V8 XJ Series/XK

303-S498

TECHNICAL BULLETIN

**“Engine Fail Safe” Displayed –
Replace Throttle Body – Normally Aspirated
Vehicles Only – Service Action S498**

Illustration 2

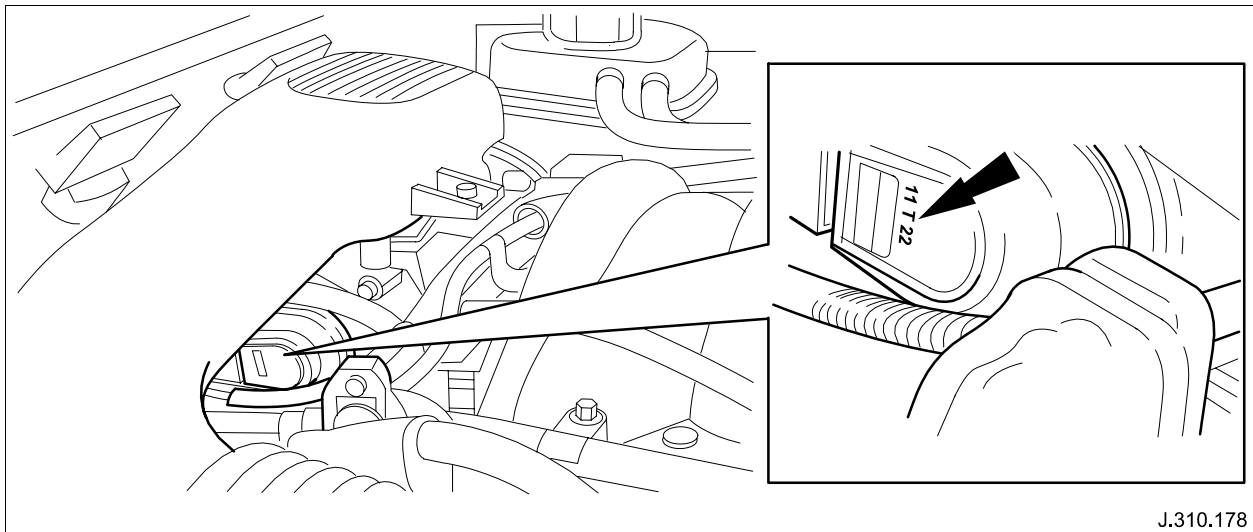
3. Check date code of the throttle position sensor (Illustration 2).

Note: If the date code is within the range 10T5 to 11T25 inclusive, the throttle body must be replaced, proceed to step 4 of this workshop procedure. If the date code is not within the range 10T5 to 11T25 no further action is required. Proceed to step 34 of this workshop procedure.

Illustration 13

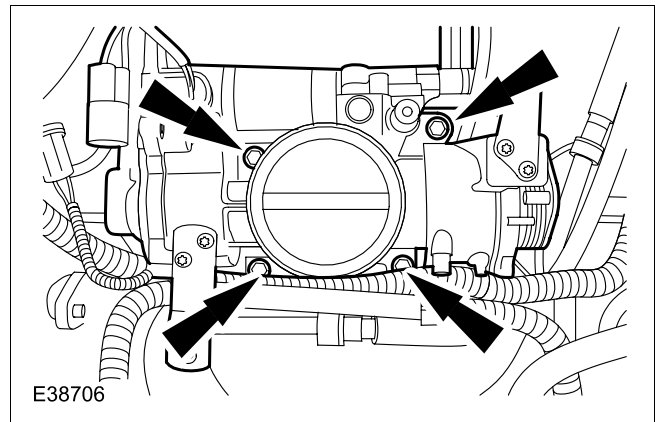
17. Remove the throttle body securing screws and throttle body, and discard the gasket (Illustration 13).

Illustration 14

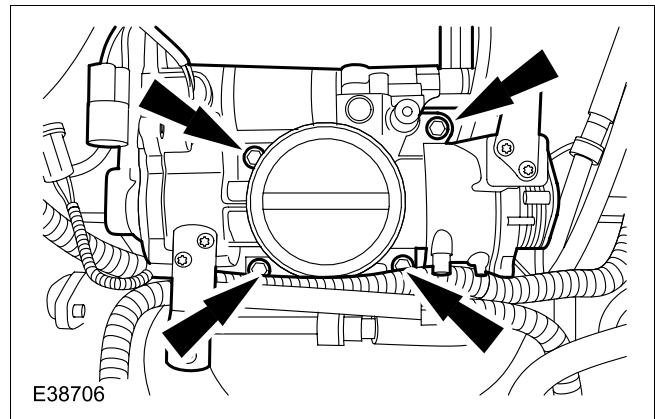
18. Install a new throttle body gasket and throttle body. Tighten securing screws to 18-24 Nm (Illustration 14).
